FEDERAL AGENCY LETTERS

Re: Fishlake National Forest - Richfield BLM Public
Lands: Quitchupah Creek Road - Draft
Environmental Impact Statement #10506

QUITCHUPAH CREEK ROAD FEIS
Responses

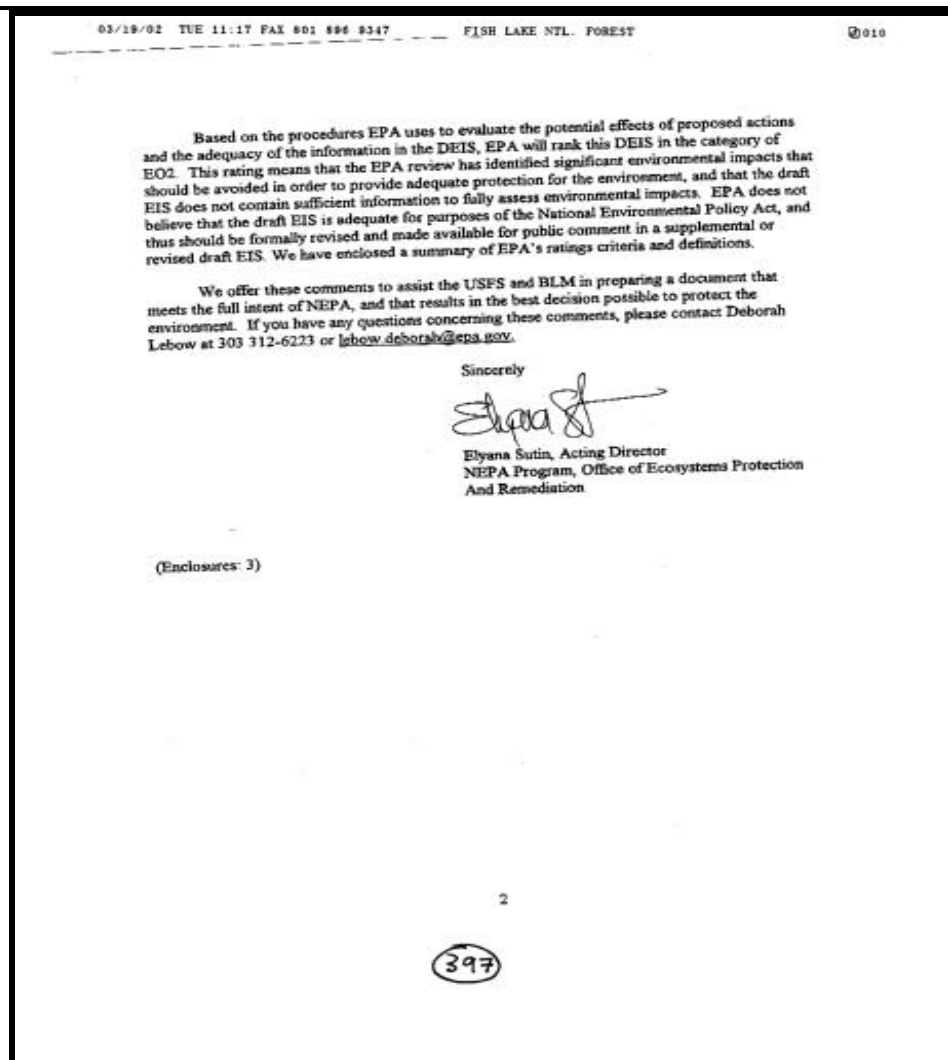
397-1
cont.

The construction costs were supplied by Jones & DeMille Engineering. The maintenance costs were derived from the actual costs of maintaining the present coal transport road, the Acord Lakes Road. Table 2.6-1 in Chapter 2 includes costs to construct the proposed road and alternatives but the projected maintenance costs and BMP costs will be included in the FEIS.

Additional information and analysis has been provided in the FEIS for hydrology, soils, socioeconomics, cultural resources, and Native American concerns.
